Installation Update

This bulletin clarifies the installation protocol recommended by DiversiTech for condensate safety overflow switches CS-1, CS-2 and CS1200.

Testing

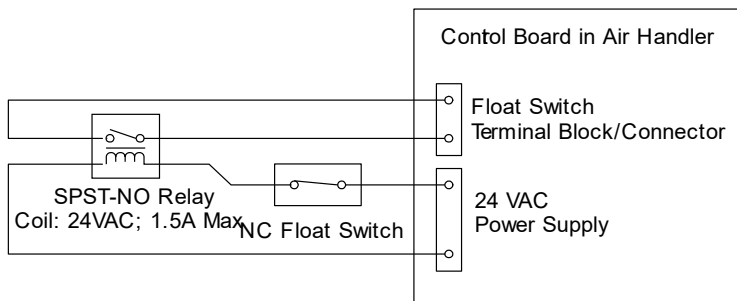
Proper system shutdown verification testing is performed by first, ensuring that the system is running normally. Then,

- For CS-1 & CS-2, raising the Pull-To-Test lever
- For CS1200, pushing the test button

And finally, check that the system shuts down as expected. If the unit does not shutdown, your unit is more sensitive to switch characteristics than traditional systems and, therefore, requires a relay. Please proceed to implement the relay solution outlined below.

Use a normally open SPST relay with a 24VAC coil (DiversiTech part # D90-290Q or equivalent) to break the condensate overflow safety shutdown input circuit. DiversiTech condensate switch CS-1, CS-2, or CS1200 should be used to make or break control power to the relay coil.
